Re: Heidi's Raspberry Jam Parking Addition

3427 Vassar Dr. NE Grading & Drainage Plan

Engineer's Stamp dated: 8-17-16 (G16D030)

| HEIDI'S RASPBERRY JAM PARKING ADDITION | | | | | | | |
|--|-----------|-----------|--------|--|--|--|--|
| GRADING AND DRAINAGE PLAN | | | | | | | |

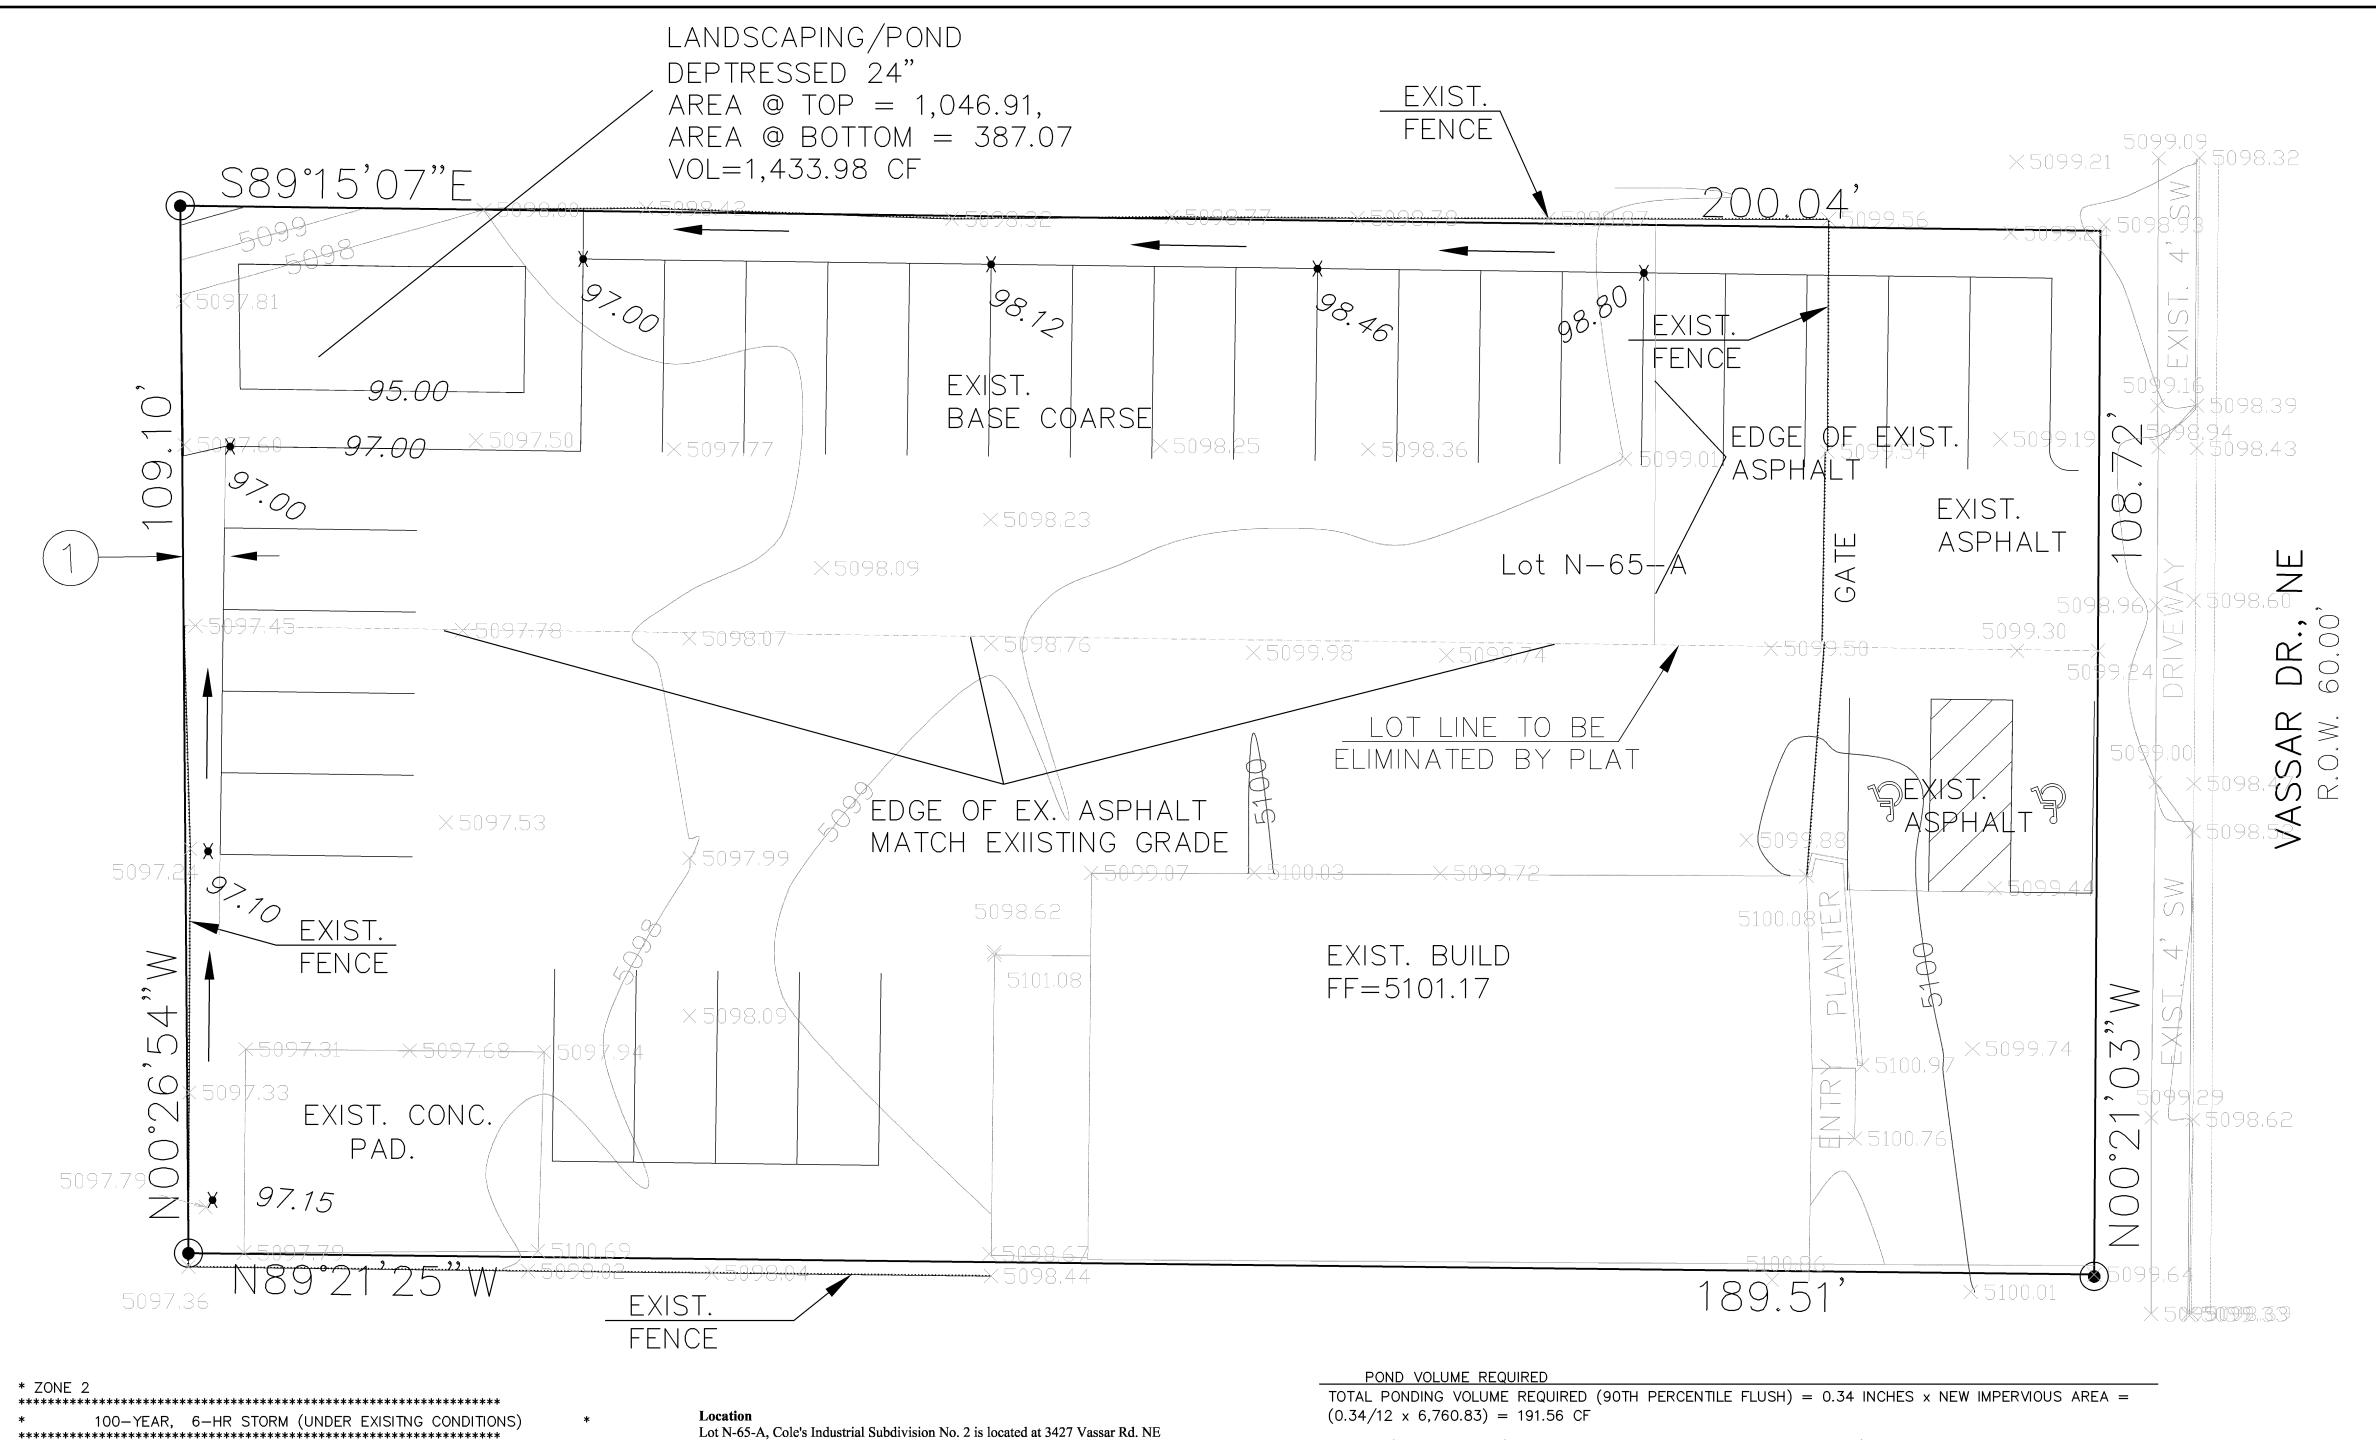
Based upon the information provided in your submittal received 8/18/2016, this plan is approved for Grading Permit and Paving Permit.

Please attach a copy of this approved plan to the construction sets prior to sign-off by Hydrology.

When completed please provide a paper copy and a PDF of the as-build for our records.
